TECHNICAL BULLETIN TB04-2015

Regarding: Tron AIS TR-8000, Check Firmware and upgrade if necessary

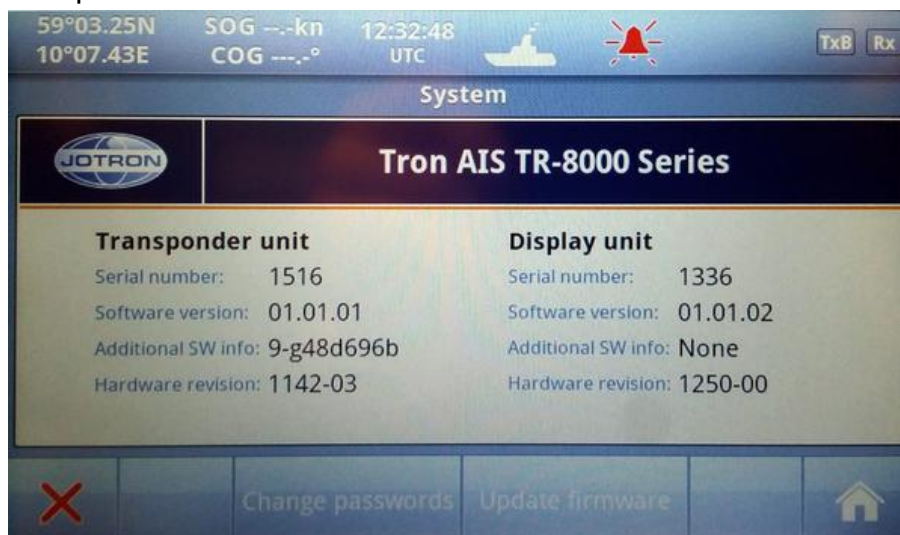
So if either Transponder or Display is replaced with a new one, or Firmware is only upgraded on one of the units, make sure that both uses the same "main" versions of Firmware.
(Same "main" version means that the 4 first digits in the Firmware version are the same)

See screenshot from Display here (newest version pr. Feb 2015) showing Firmware version of both Display and Transponder.

If your Firmware is incompatible according to table above, please contact your Dealer/Distributor to upgrade unit(s).
